Subject: Baldon Wind Farm (SSD-40138508) – Environmental Impact Statement

ATTACHMENT A – BCS Assessment Summary for Baldon Wind Farm Environmental Impact Statement (SSD-40138508)

ATTACHMENT B – BCS detailed advice for Baldon Wind Farm EIS

Figure 1: Example of location where avoidance of Plains-wanderer known habitat has not occurred. A new access track has been placed in native vegetation and the proponent has not used the nearby existing farm access track (to the south).

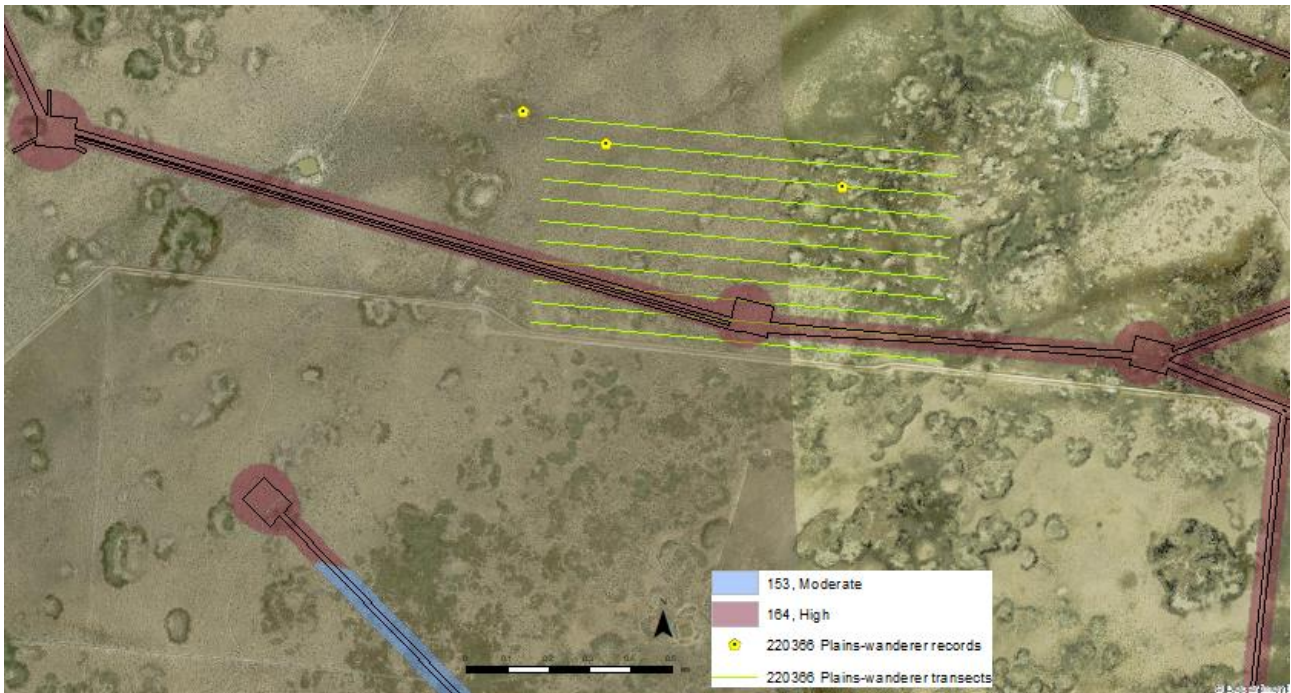
Figure 1 is an example of a known location of three Plains-wanderer records from targeted surveys. The development footprint including wind turbine generators (WTGs), and access tracks runs through areas of native vegetation and known habitat for the species. There is an existing access track to the south within 30 metres, which has not been used in project design to avoid impacts to this species and native vegetation. There are similar scenarios throughout the subject land where access tracks have not been designed to avoid and minimise impacts by using existing access tracks.

Figure 2: Example of areas in red outline, within vegetation zone 'PCT 164 high' where changes in PCT and/or vegetation zones supporting microhabitats may have been misidentified.

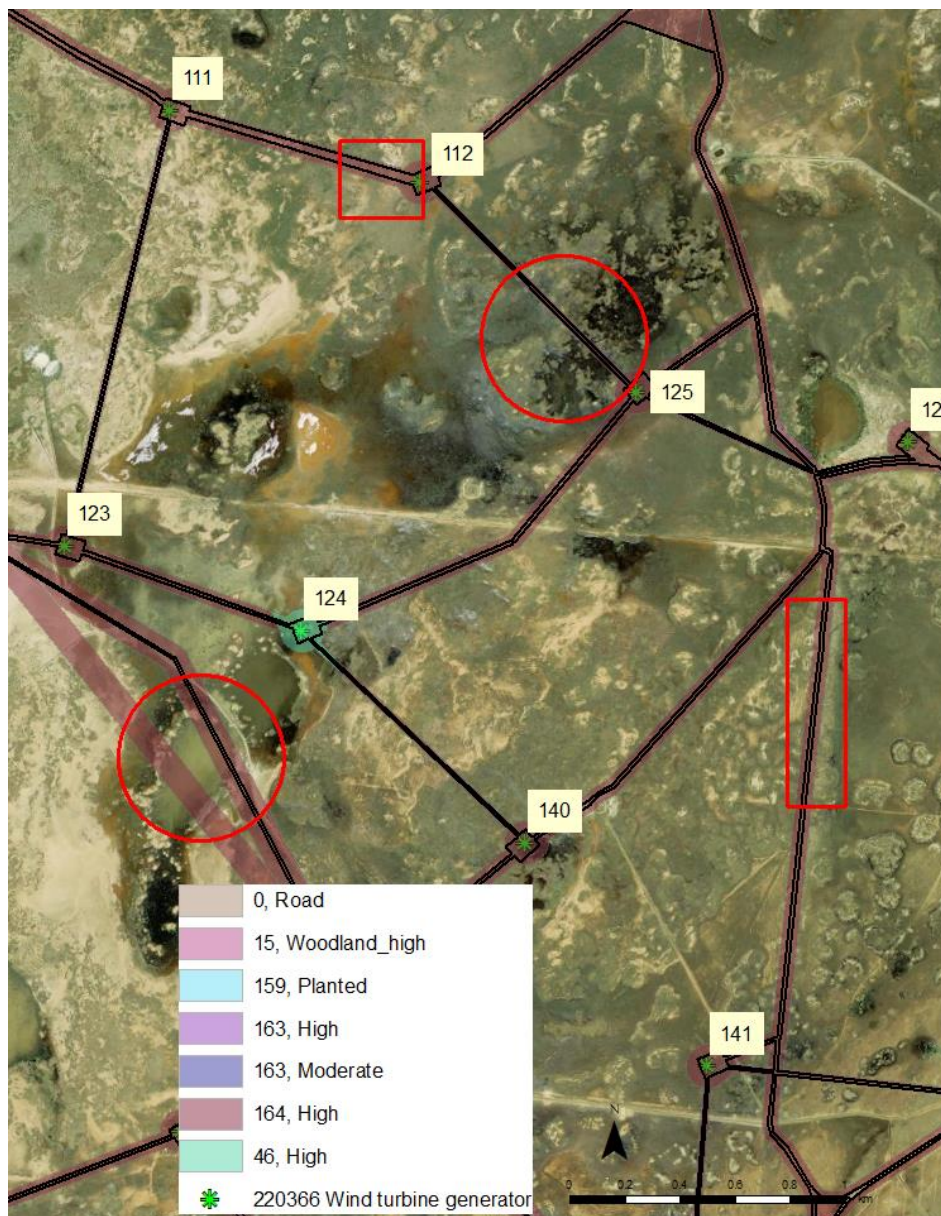
The BDAR has mapped about 2,188 hectares of PCT 164 in the development footprint in two vegetation zone conditions (high and moderate). A review of these vegetation zones on recent aerial imagery shows apparent changes in vegetation with clearly visible smaller wetlands and gilgais (see Figure 2).

For example, Figure 3-19 and Appendix L.1 shows the soil and vegetation patterns that have all been mapped as PCT 164 in high condition state. The accredited assessor has not captured the differences in soils and vegetation that support ephemeral wetlands and gilgai in the stratification of BAM plots and vegetation zones.

- 7.1. Revise the PCT mapping to more accurately reflect vegetation and edaphic patterns evident on aerial imagery including wetlands and gilgai.

Figure 6: Example of species polygon buffers and approach for *Brachyscome papillosa*. Red circles represent gaps between observed records and species polygons in associated PCTs.

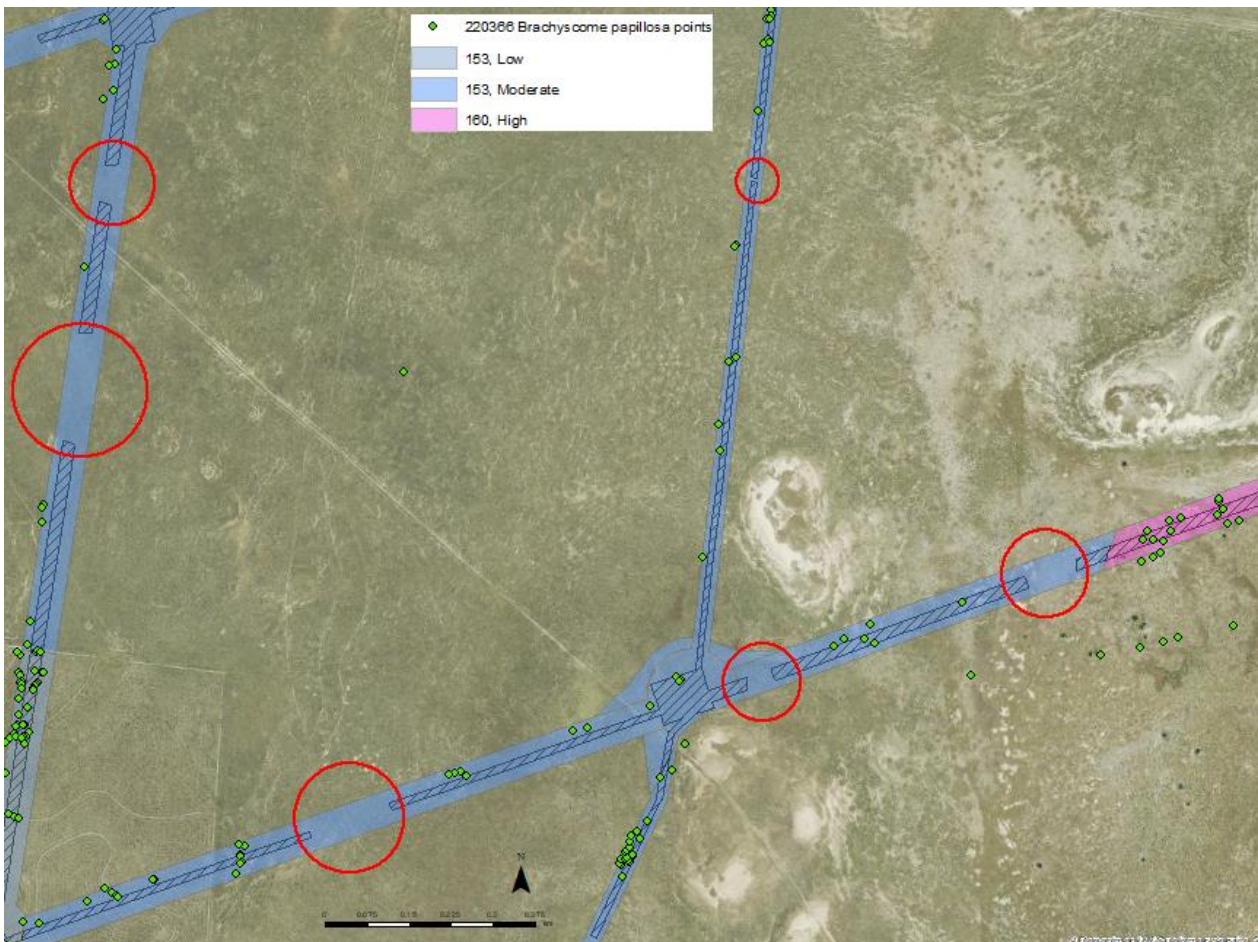
Species polygon buffers for observed 'area' threatened flora species need to be prepared in accordance with section 5.2.5 and Box 2 of the BAM. Justification needs to be provided for using a 50-metre buffer for *Maireana cheelii* and 100 metre buffer for *Brachyscome*. It is also not clear why small gaps of suitable habitat in associated PCTs between species polygons have been excluded (see Figure 6).

- 12.1. Provide justifications for species polygons buffers. In areas where there are small gaps between species polygons in the same associated PCT, review the extent of suitable habitat in the species polygon.
- 12.2. Revise the *Pilularia novae-hollandiae* species polygon to incorporate PCTs and habitats associated with PEC East records for the species in the subject land.
- 12.3. Complete additional targeted surveys before the RTS report is submitted for assumed presence flora species, and update species polygons subject to outcomes of survey results.

Figure 7: Connected patch of PCT 46 ‘high’ (highlighted in blue) that has been assessed plot by plot.

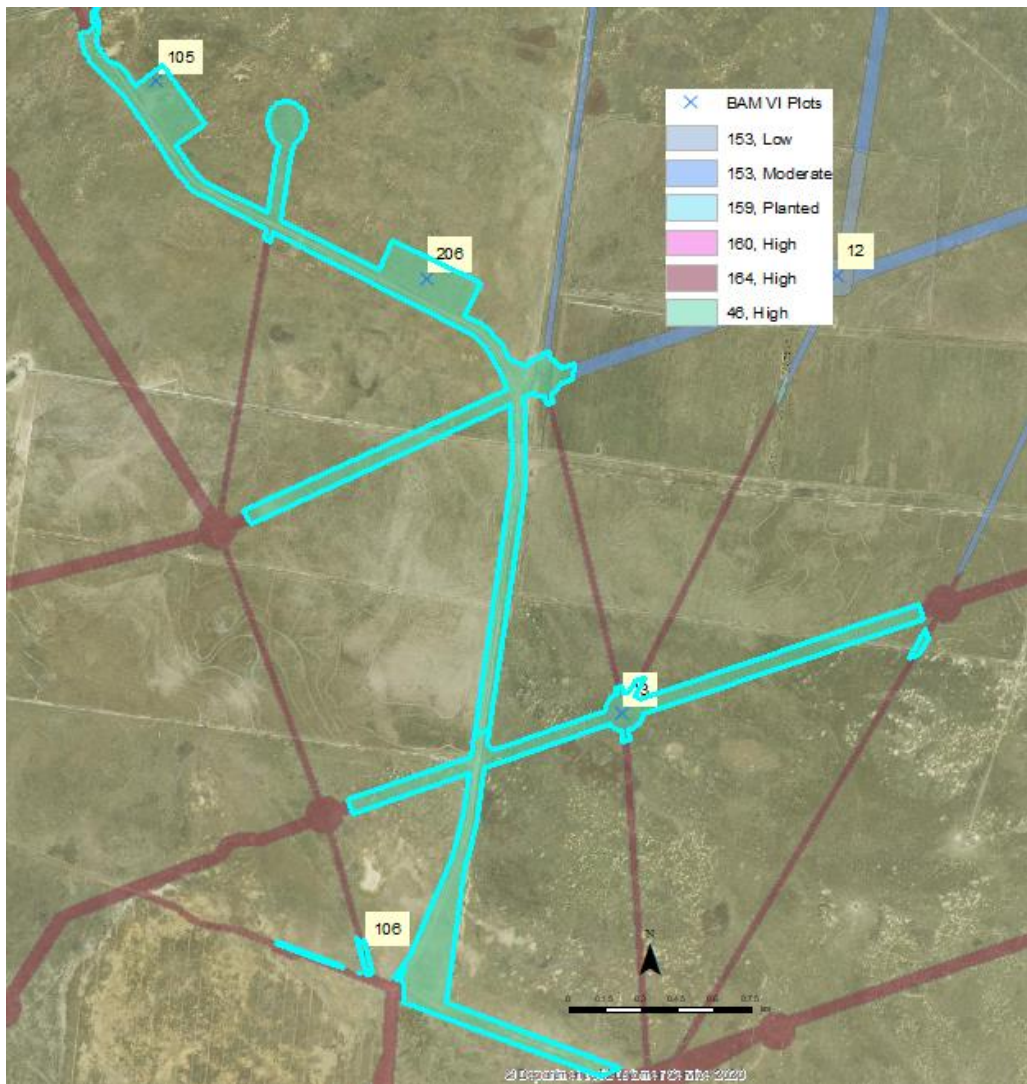
The proponent has appropriately assessed the natural grasslands against the Australian Government listing advice (Table 5-1). However, the listing advice criteria specifically refers to assessment at the 'patch' scale. Vegetation zone '46 high' occurs as discontinuous patches across the subject land. The assessor has completed the assessment in Table 5-1 against the criteria on a plot-by-plot scale regardless of whether each plot occurs in the same patch (see example in Figure 7). By limiting the criteria assessment to plots, this also does not account for the variability within the patch. While using plots to inform the assessment is appropriate, it should be supported by additional assessment across the entire connected patch.

- 20.1. Revise the step 1 and 2 of the assessment criteria for the Natural Grasslands of the Murray Valley Plains TEC at the patch scale rather than at the plot level.
- 20.2. If required, recalculate impacts to the Murray Valley Plains TEC and reassess impacts.
